APPLICATION FOR CONSTRUCTION OF PAVED SIDEWALK/ DRIVEWAY

No. <u>B-20-3503</u>

Driveway Review Form

Address: 257 Maxfield St

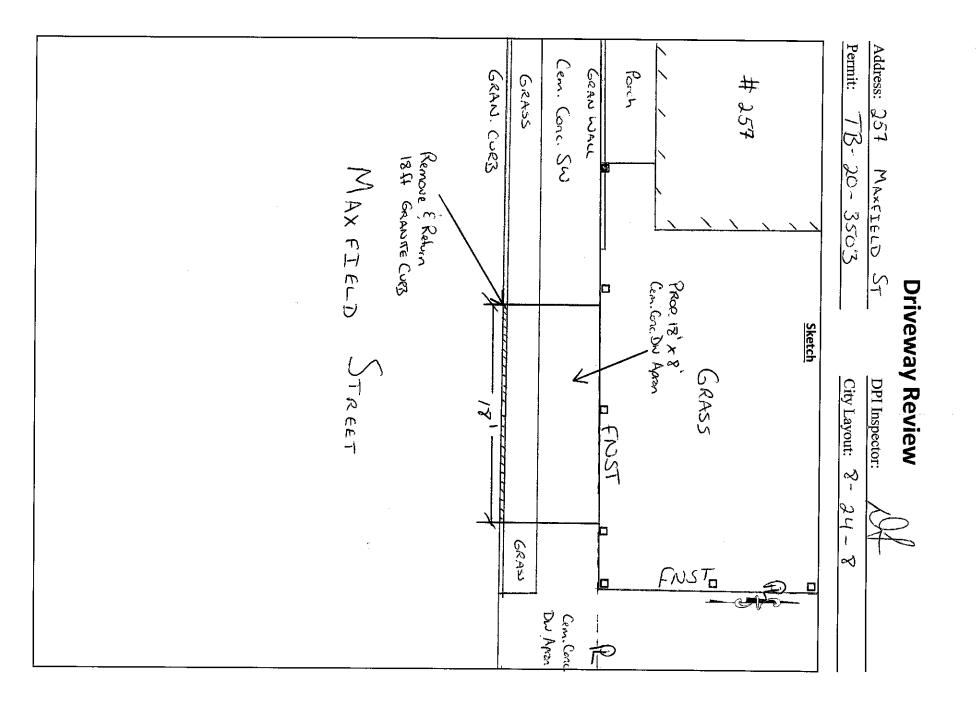
Additonal Inspection Notes: 1.Remove&return 18' gran.curb. 2.Remove

with most current DPI Specs. 18'x8'cem.conc.SW & grass ribbon area. 3.Install new 18'x8'cem.conc.DW apron in accordance

joints. ***Must meet all grading requirements. Sidewalk panels must be saw cut at existing tooled
